DRB CASE ACTION LOG - BLUE SHEET

Project #: 1009344

Project Name: SUNPORT PARK

13DRB-70405 MAJOR – SITE DEVELOPMENT PLAN FOR BUILDING PERMIT

LANDSCAPING PLAN
The Hilltop
LANDSCAPE ARCHITECTS & GARDENERS
Cort, L.P. #28458
7908 Edin NE
Albuquerque, NM 87154
Ph. (505) 898-8890
Fax (505) 898-7737
www.hilltoplandscaping.com

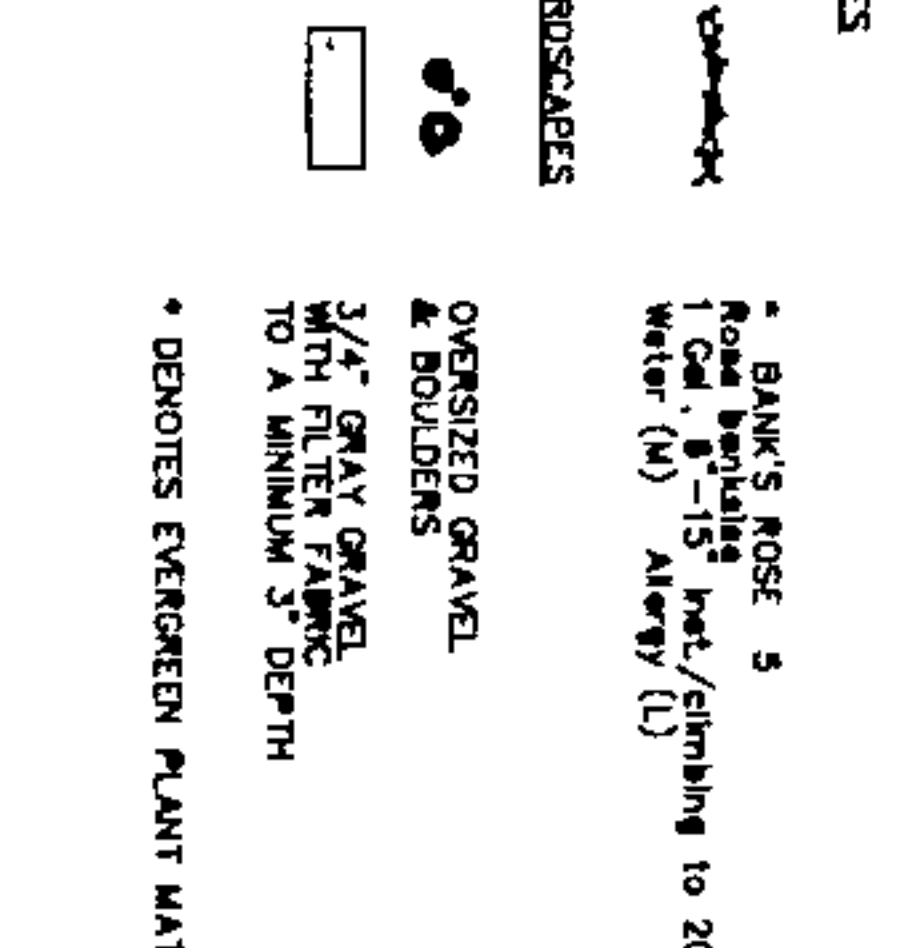
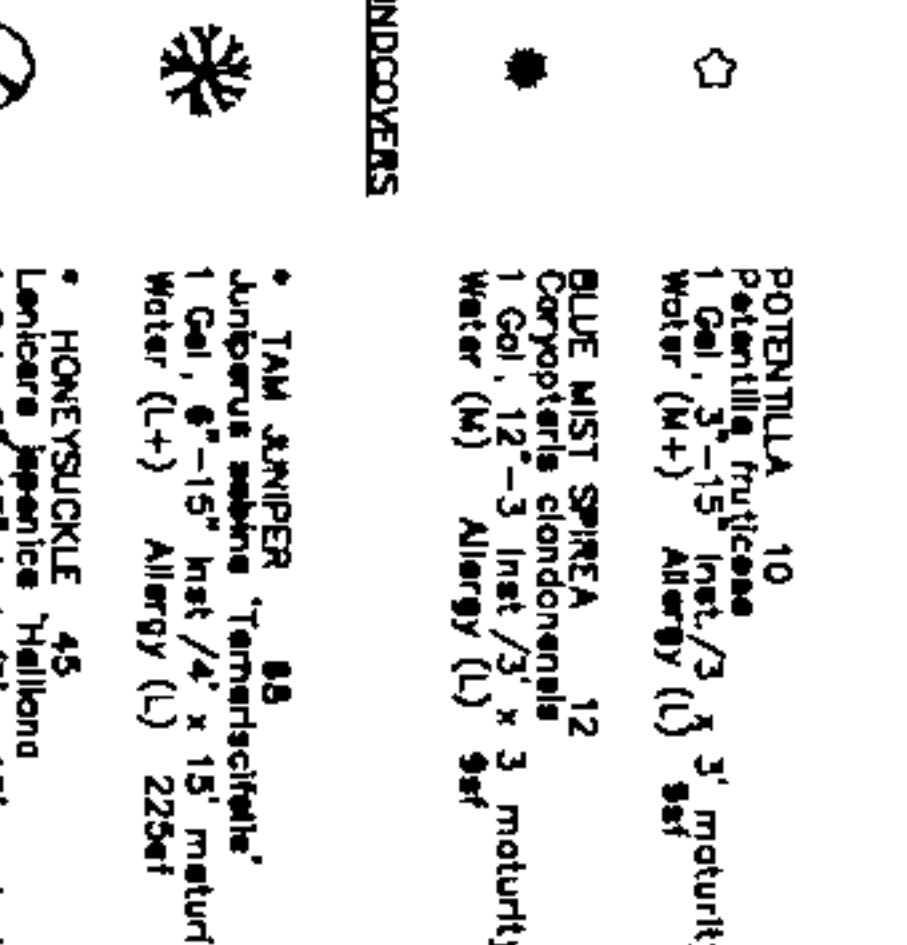
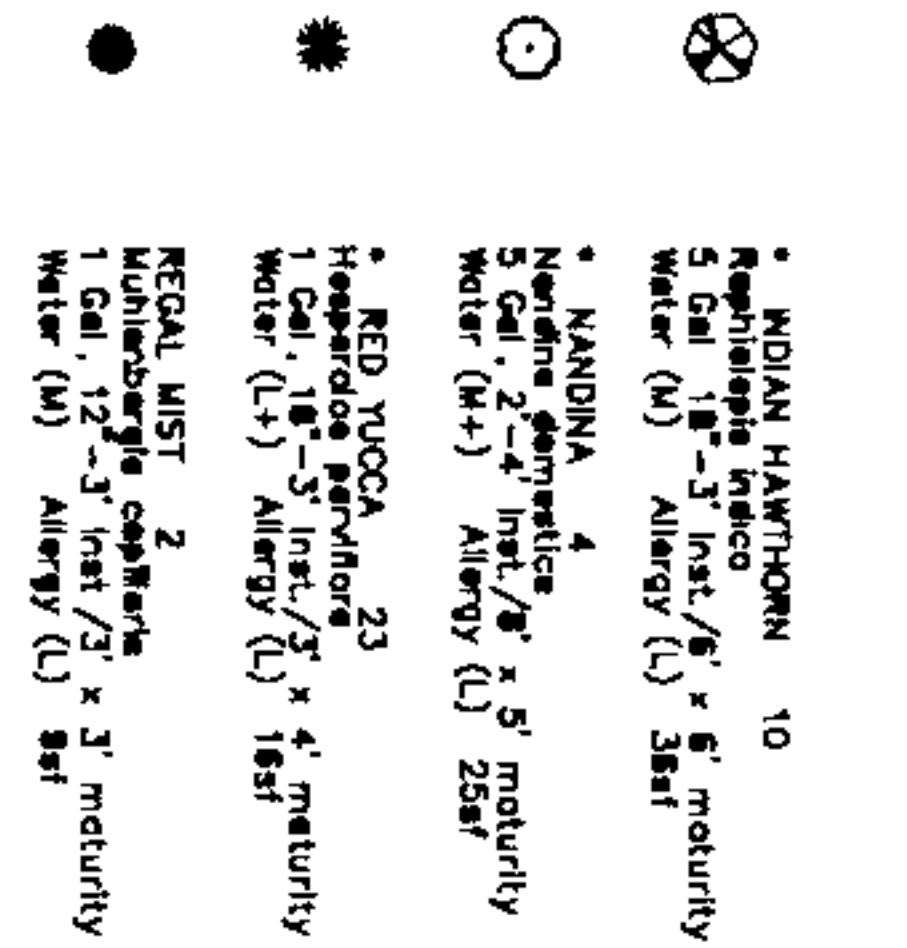
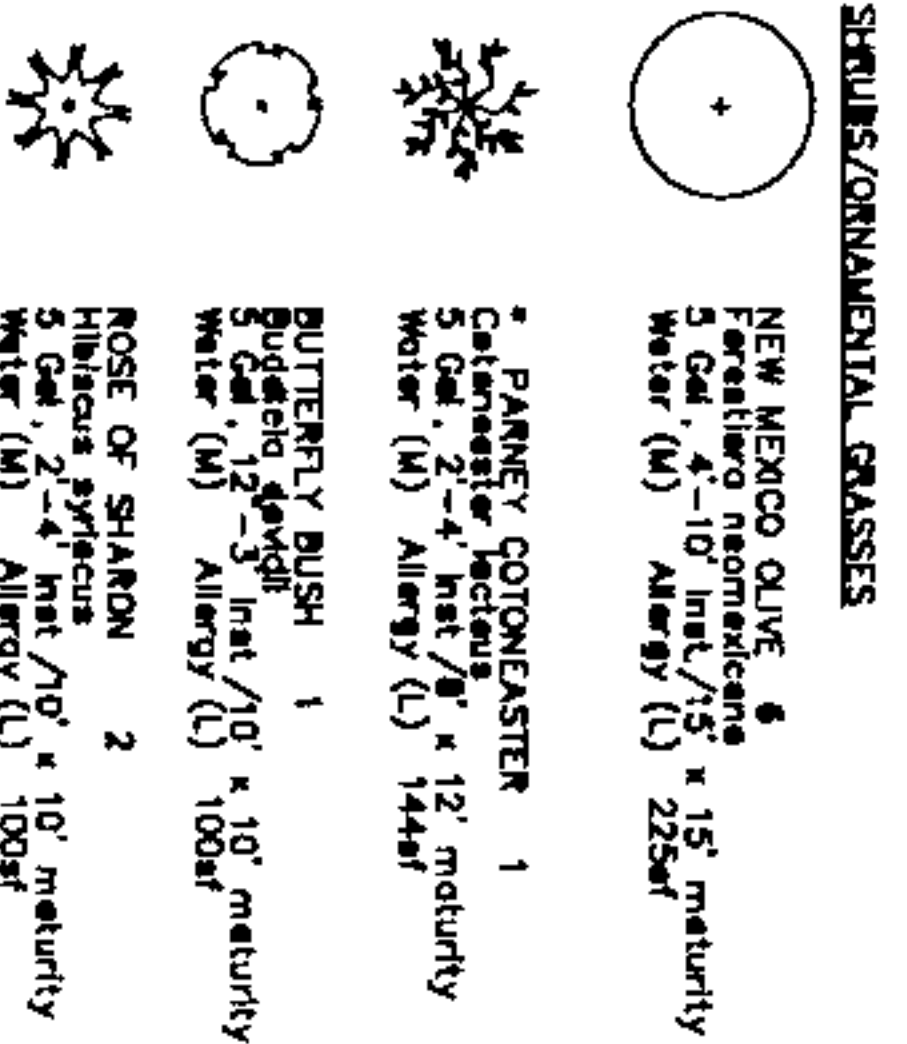
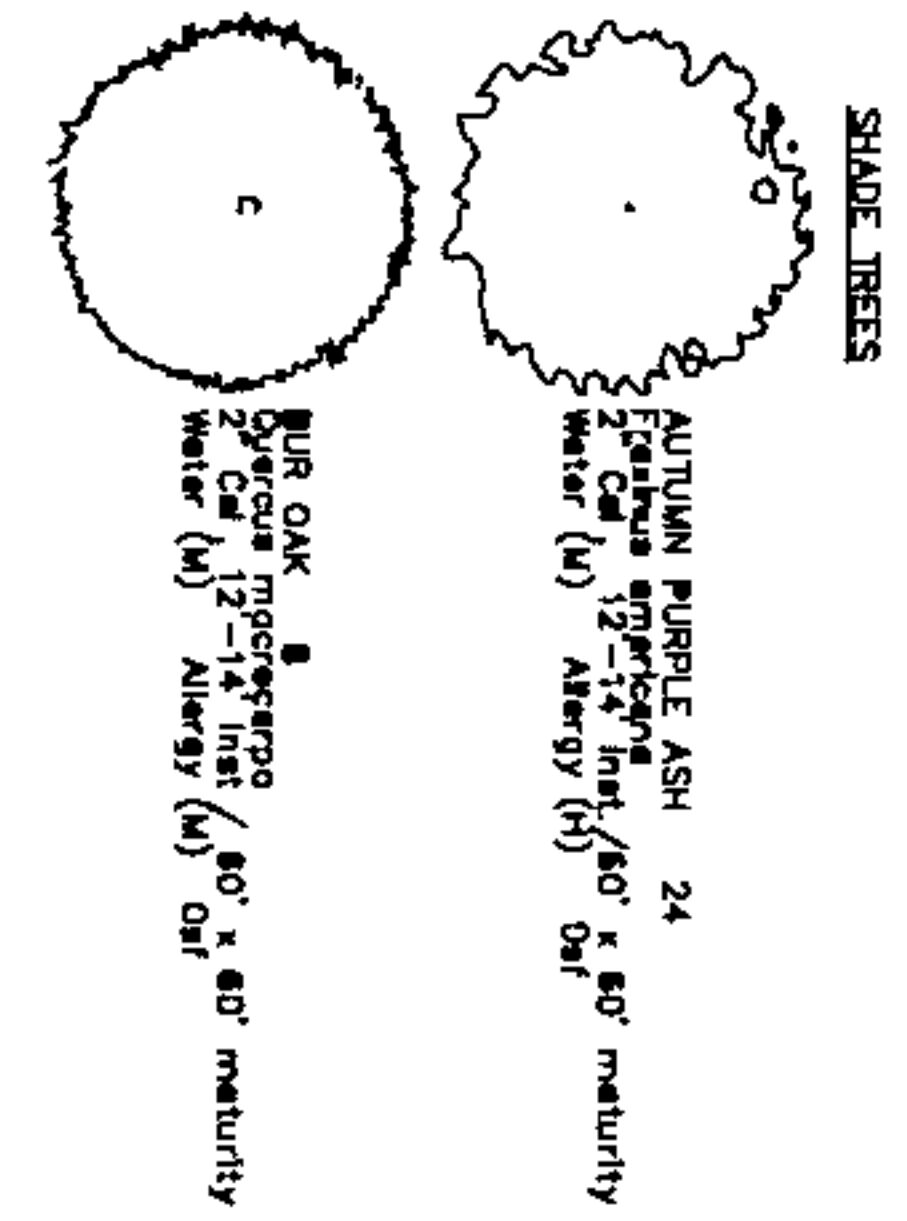
Demonstrate that the signs and landscaping do not interfere with the sight distance of the entrances. Please add the following note to the Landscaping Plan: "Landscaping and signing will not interfere with clear sight requirements. Therefore, signs, walls, trees, and shrubbery between 3 and 8 feet tall (as measured from the gutter pan) will not be acceptable in this area."
